APPLICATION NO.	FILING DATE	FIRST NAMED INVENTOR	ATTORNEY DOCKET NO.	CONFIRMATION NO.
09/725,470	11/30/2000	Sang-Duk Lee	6192.0169.AA	1695

# Office Action Summary

## DETAILED ACTION

**FIG. 4**

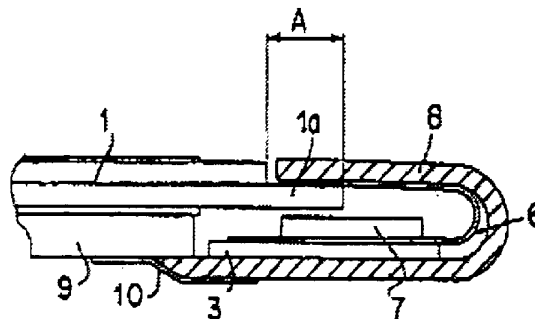
As to claim 1, Hashimoto discloses (summary of the invention, col. 2, line 31 through col. 3, line 26) an embodiment shown in Figure 4 (col. 5, line 18 through col. 7, line 52).

Figure 4 shows a liquid crystal display device comprising: a display unit having a liquid crystal display panel, 1, and a flexible printed circuit, 6, which is attached to the

liquid crystal display panel, for applying driving signals to said liquid crystal display panel for driving the liquid crystal panel; a light conductive plate, 9, (Applicant's back light assembly) which provides a light to the display unit; a glass plate to which everything is attached, 1a, (serves as Applicant's mold frame) for receiving the liquid crystal display panel and the back light assembly; a chassis, being coupled to said mold frame (not shown, see Figure 10), for fixing said liquid crystal display panel and said back light assembly to said mold frame; and a frame member, 8, that has a moderate level of resiliency for nipping the liquid crystal display panel, 1, and the circuit board, 3, (col. 5, lines 58-68) (Applicant's support means for supporting the flexible circuit board towards the mold frame).

FIG. 7

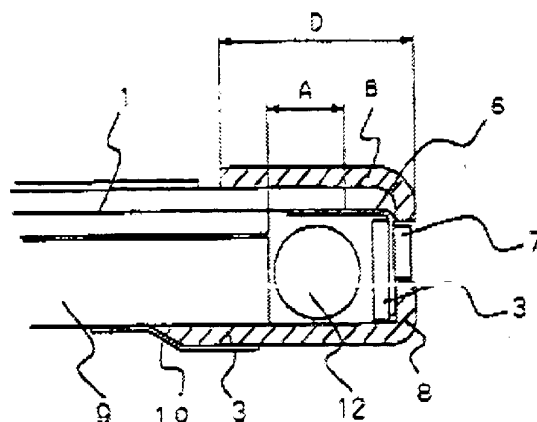
As to claim 2, Hashimoto discloses in Figure 7 a recess for receiving the integrated circuit, 7, in the frame member, 8, (col. 9, lines 3-7).

Hashimoto is evidence that ordinary workers in the art of liquid crystals would find the reason, suggestion, or motivation to add a recess as needed to receive a circuit board in a frame.

Therefore, it would have been obvious to one having ordinary skill in the art of liquid crystals at the time the invention was made to modify the LCD with a recess for receiving the circuit board in the frame.

FIG. 3

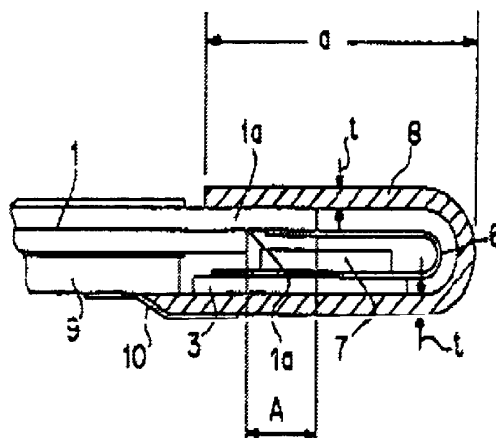
As to claims 2-4, Hashimoto discloses in Figure 3, a recessed portion between glass, 1a, and Integrated circuit, 7, (Applicant's portion of the receiving recess at the upper end of the outer side surface) of the device is deeper than a recessed portion between the liquid crystal display panel, 1, and the circuit board, 3, (Applicant's portion of the receiving recess at the lower end) thereof.
